City of Burnsville

Transition Plan

Parking Ramp

Accessibility Review

Photo 4: Relocate the cigarette disposal so it does not obstruct maneuvering clearance at the ground level east elevator lobby.

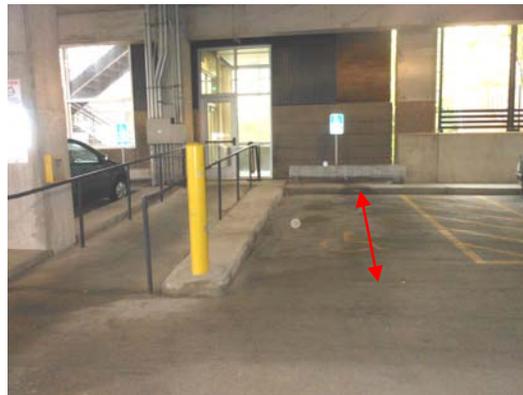
20B3	<i>14322</i>	Relocate object to achieve needed maneuvering clearance on the pull side of the door. ICC / ANSI 404.2.3, Table 404.2.3.1 <i>Relocate the cigarette disposal so it does not obstruct the clearance at the door. Photo 4.</i>	1	\$50	\$50	3			
-------------	--------------	--	---	------	------	---	--	--	--
